PLANNING & ZONING COMMISSION

October 16, 2024 at 10:00 AM

RE: **Application for a Minor Site Plan: Fifth Third Bank, Mount Dora Groves South PUD (Project Name)**, 19160 US Highway 441, Mount Dora (Site Address); Andrew J. Hupp, One Oak MD Groves, LLC (Property Owner) Angelina Makwoski, BDG Architects LLP(Applicant); Nisit Sapparkhao, Infinity Engineering Group, LLC (Engineer); Patrick D. Cunningham, Infinity Engineering Group, LLC (Landscape Architect); Jack Marshall, BDG Architects, LLP (Architect).
Project No. SP24-08

Staff recommends approval of the above-referenced Site Plan request, subject to modification of proposed bicycle racks.

SITE ACCESS PLAN

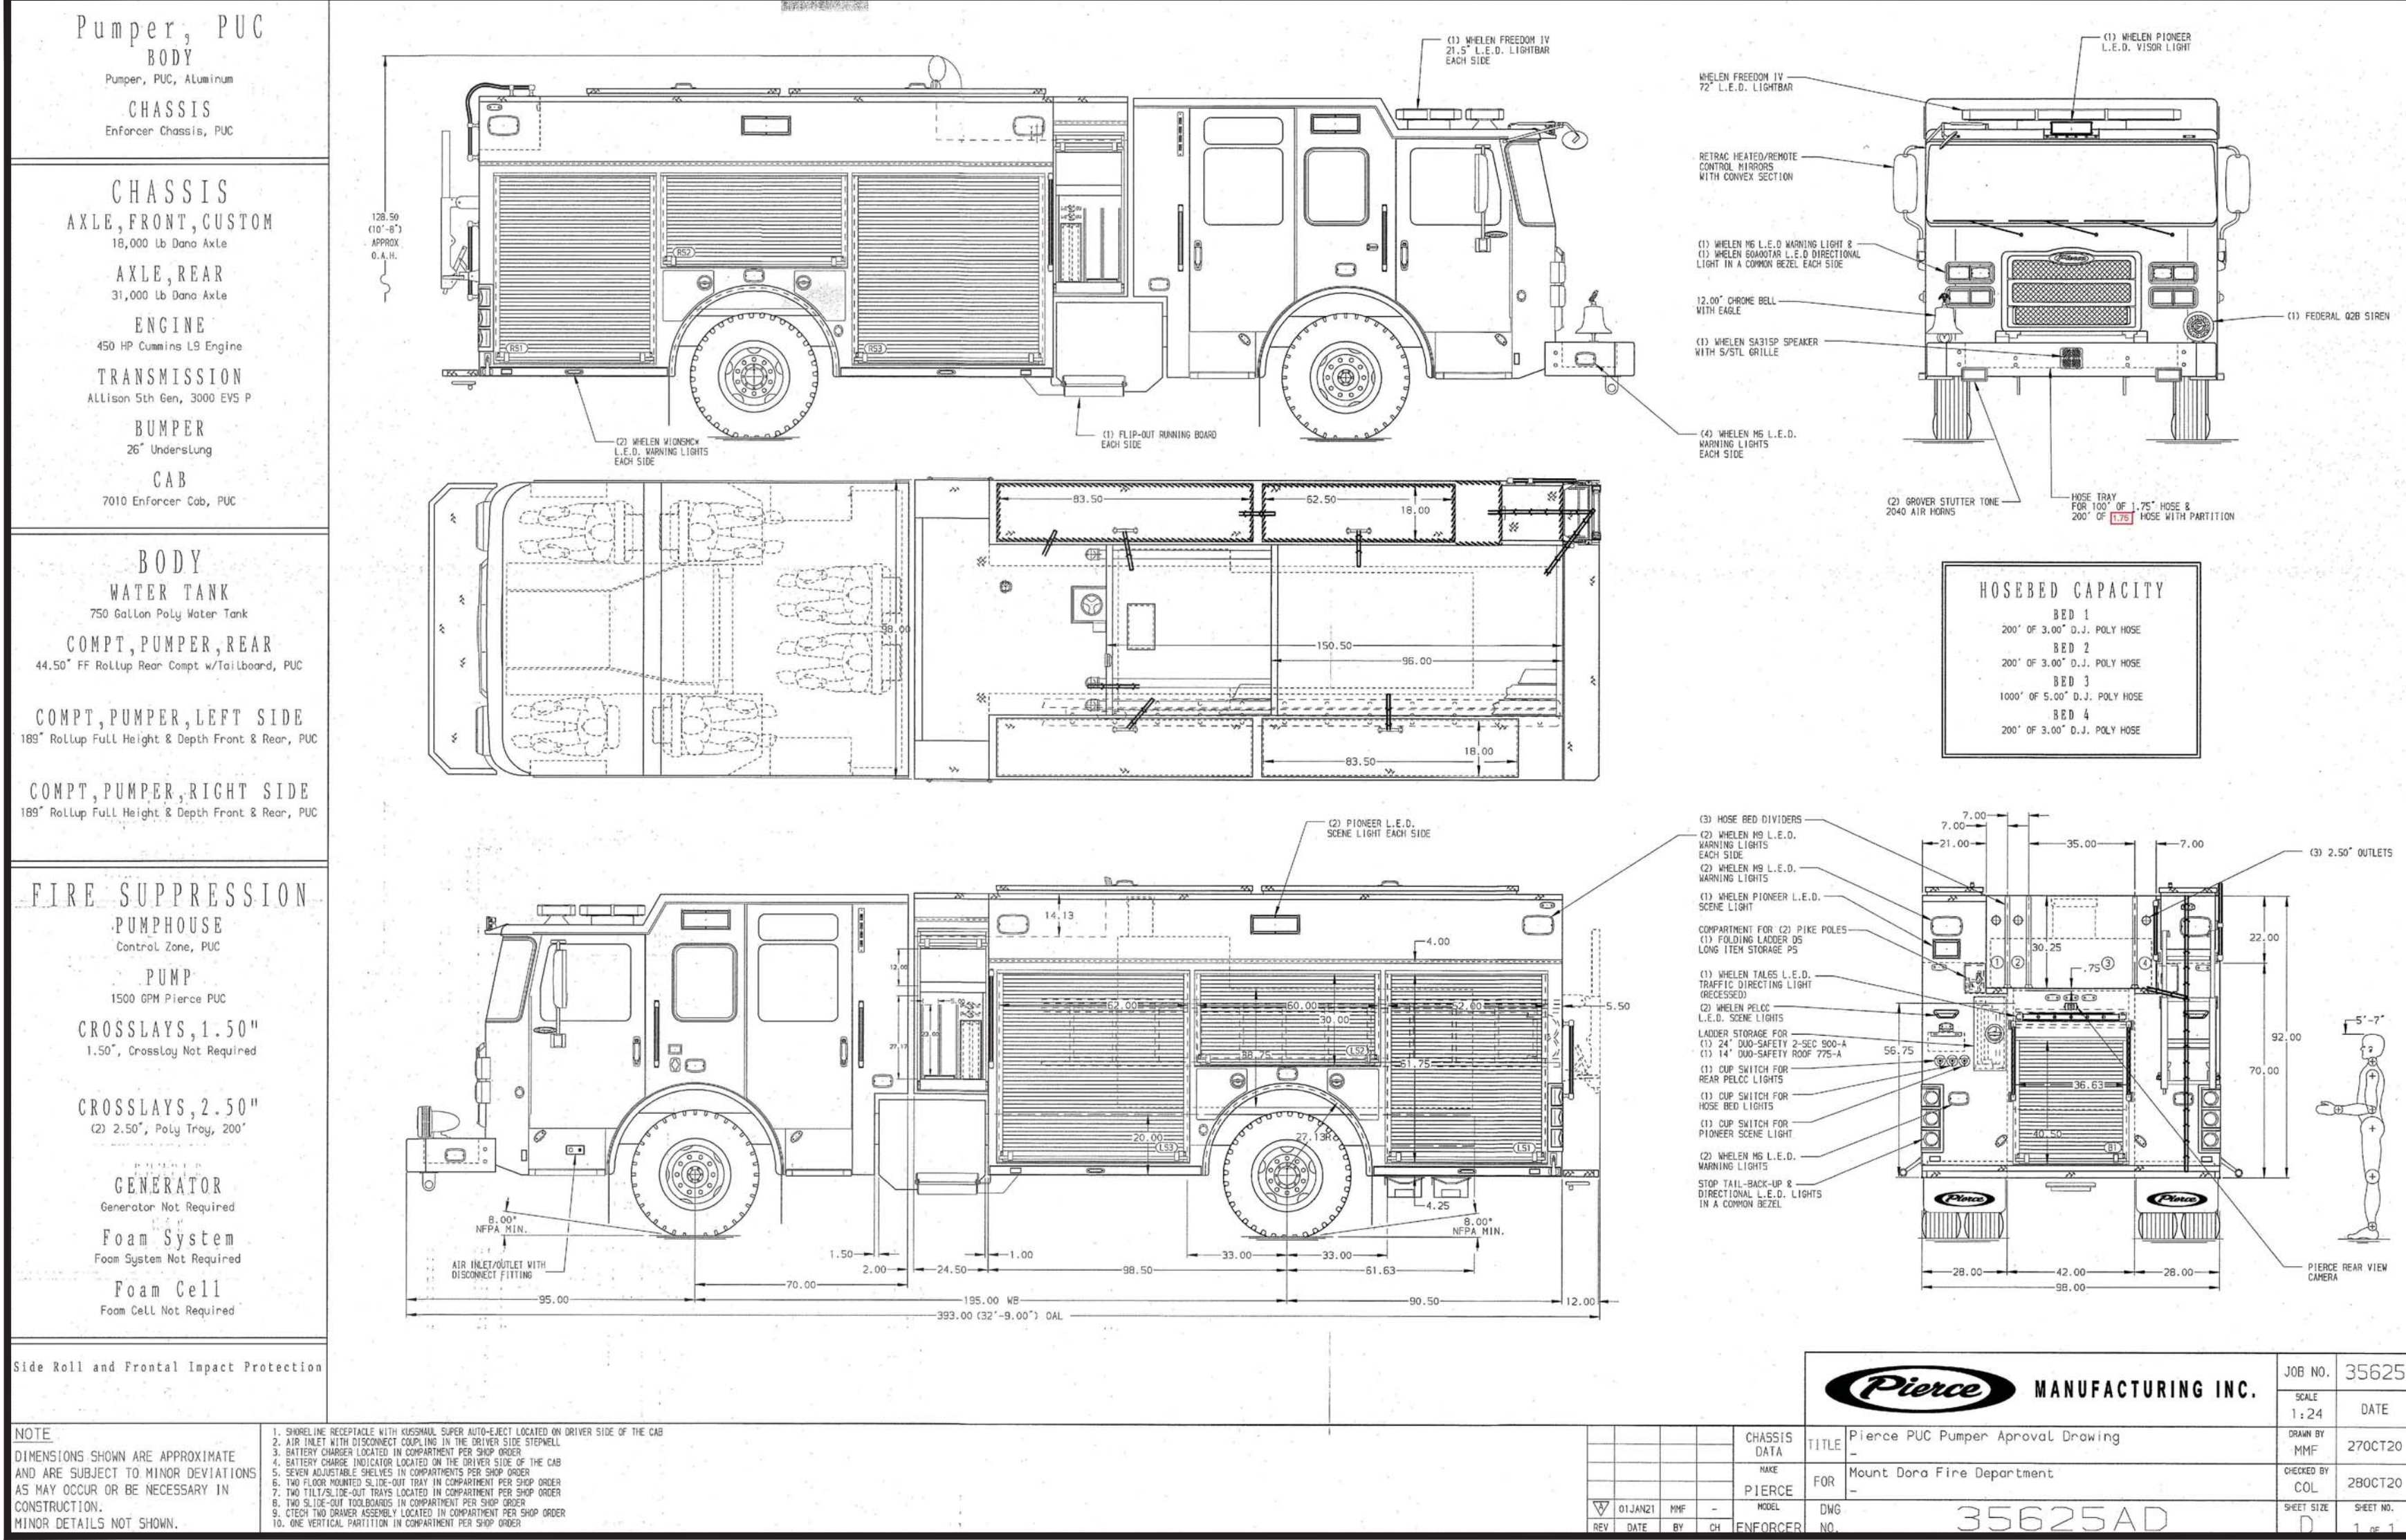
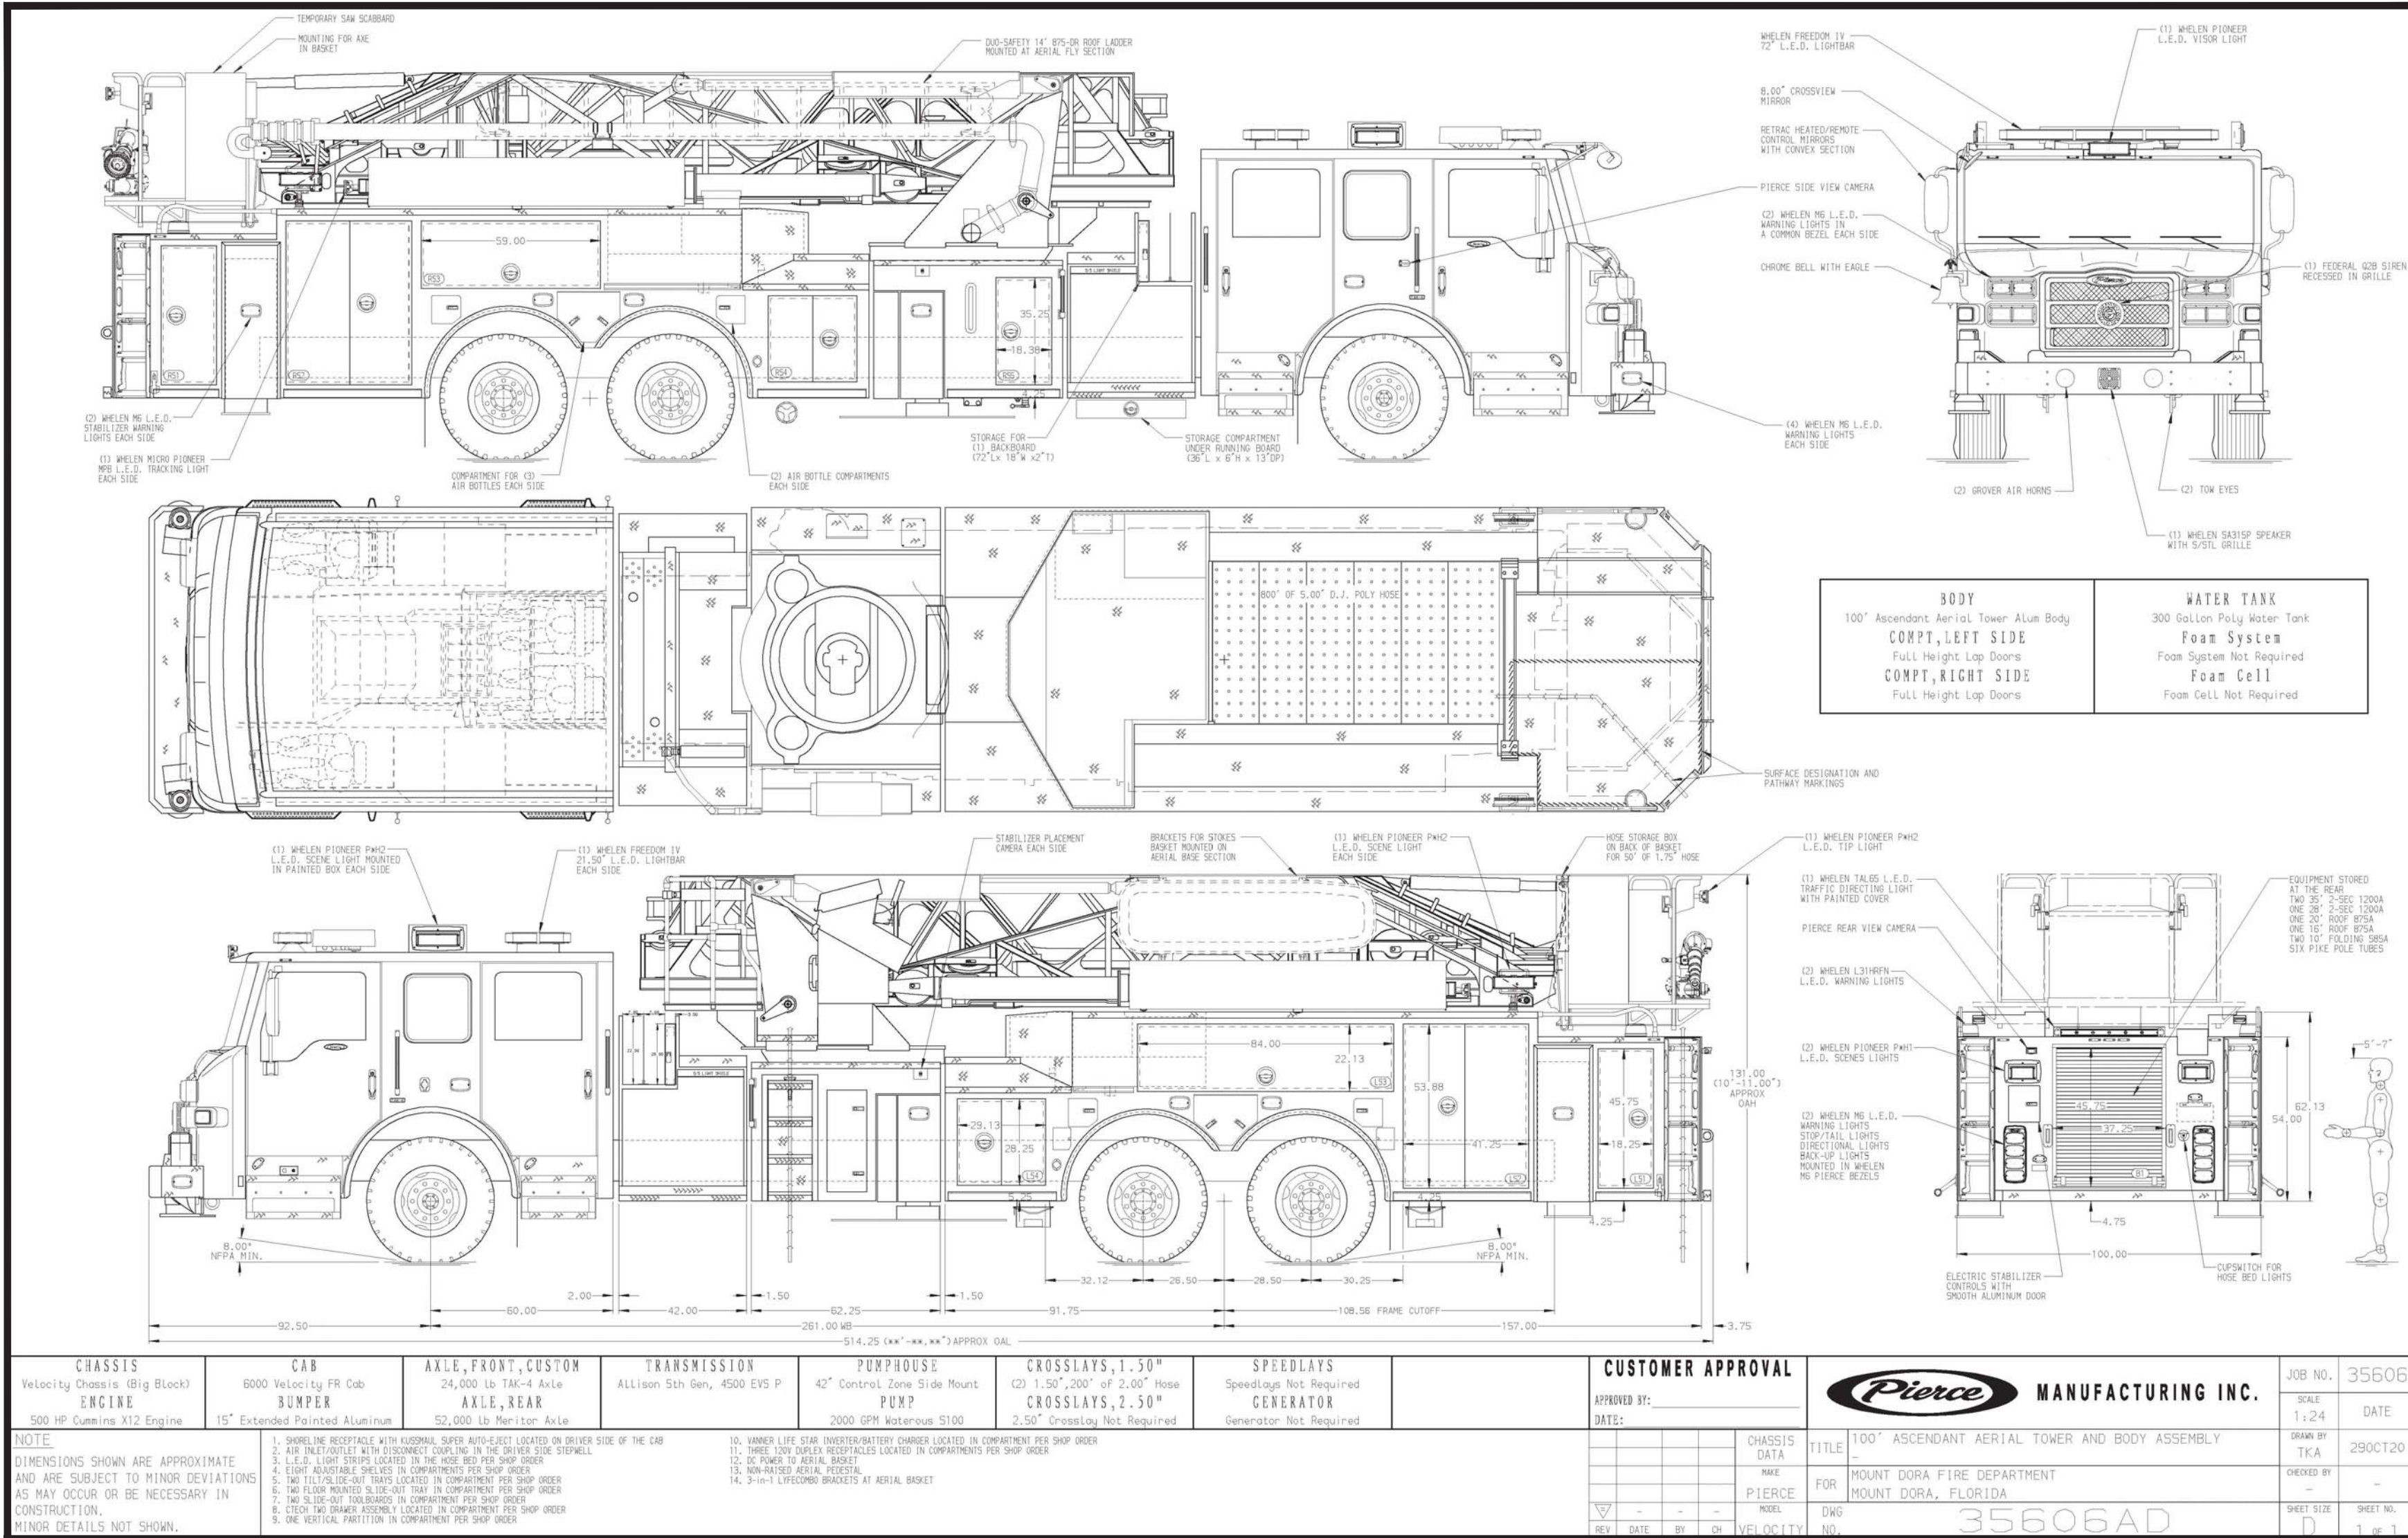
1. Ensure the Site Access Plan (Plan Sheet SA01.01) is compliant with the City’s standards for fire truck turn radius; enclosed are the Engine Specifications and turning radius reports for your use and reference.
